T16: Reason for Moving: This turbine has been moved to improve rotor spacing in a congested part of the site.

Figure 2.12p
Infrastructure Design Review
- Turbine 16

Engineering

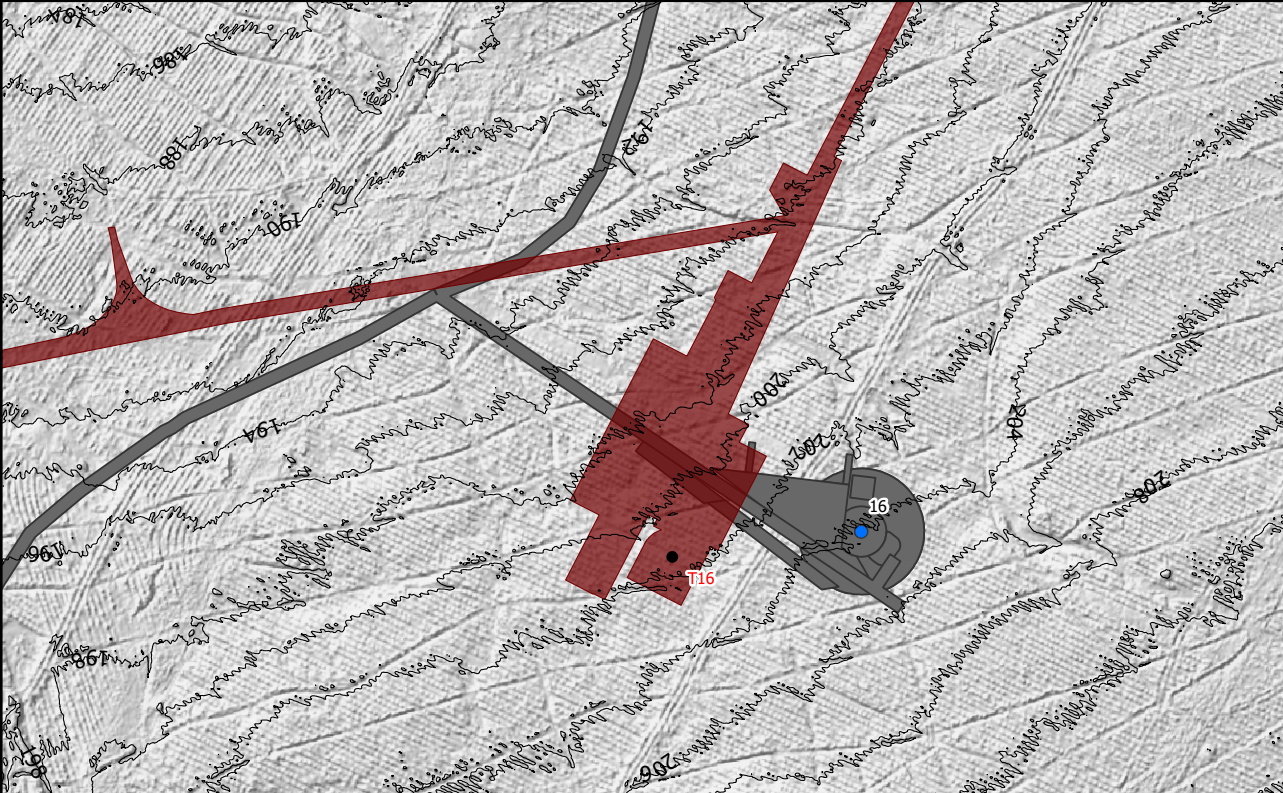
Engineering: The hardstanding for the proposed layout is larger than the current consented layout. Due to this it is not possible for it to meet the track as shown in the consent. The hardstand has been rotated and the track as been realigned as required.
The plan for turbine deliveries is to drive directly onto the hardstand and offload components. The unloaded vehicles will then use the previous junction to turn and exit the site.

Geology

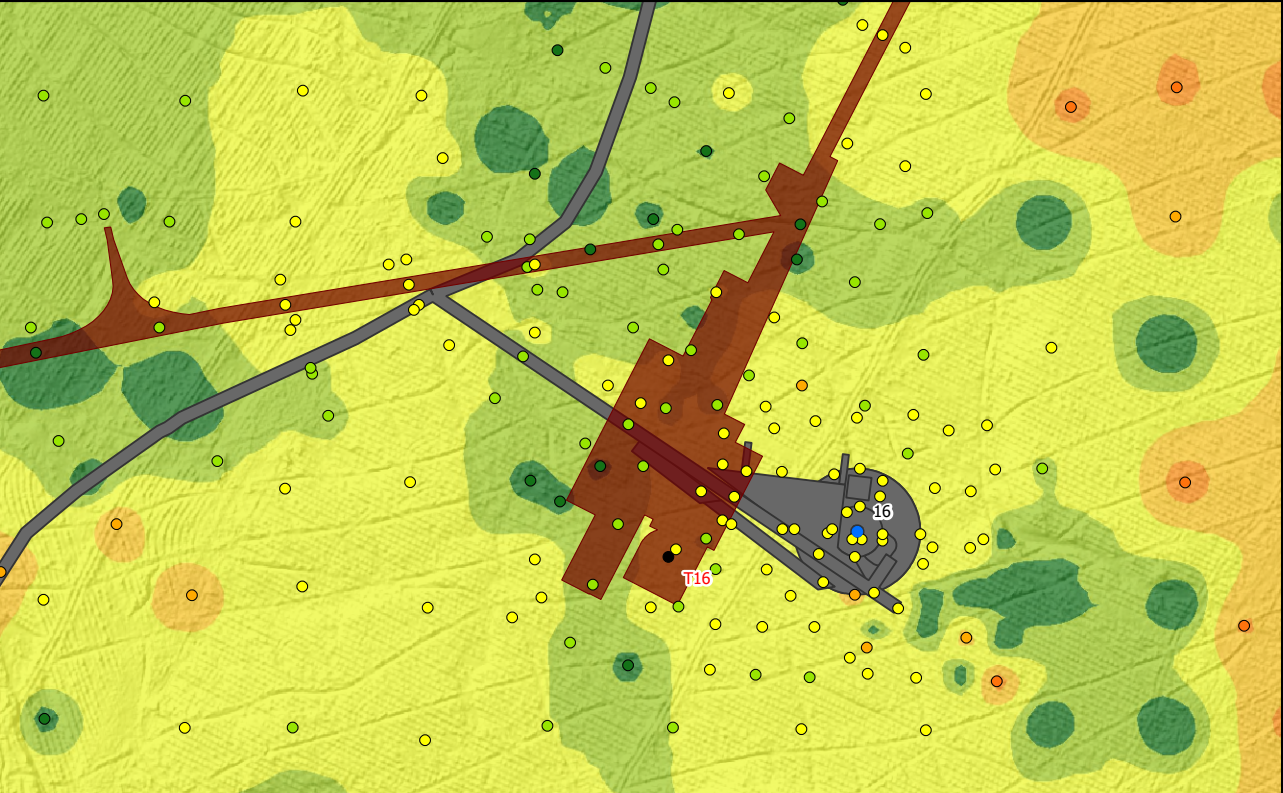
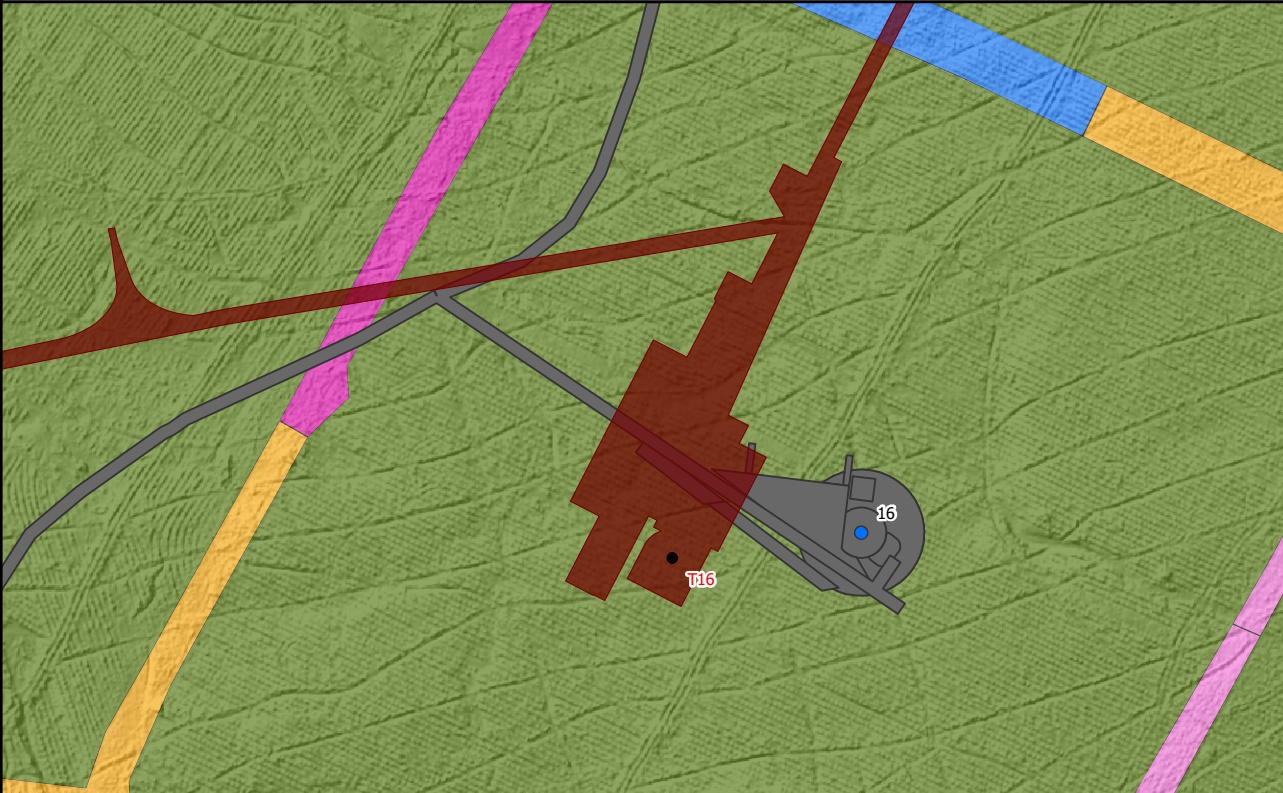
Geology Impacts: The alignment of the track now follows the contours of the hill rather climbing up the gradient, this is likely to result in less cut and fill during excavations at the construction phase.

Ecology

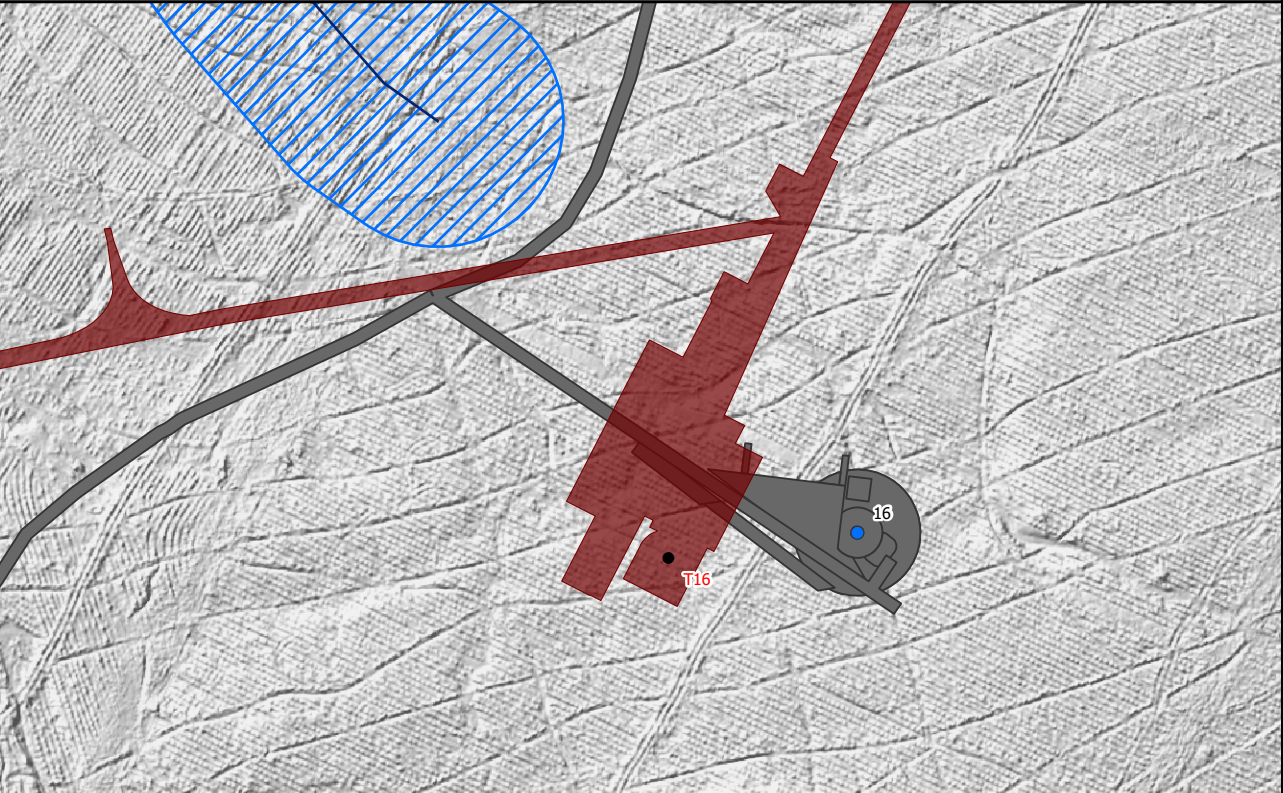
Ecology Impacts: The turbine and infrastructure is located in an area that was commercial coniferous forest. The trees have now been felled. Landowner (FLS) has begun peat restoration in this area.

Hydrology Impacts: There are no water buffers within the area adjacent to the turbine location.
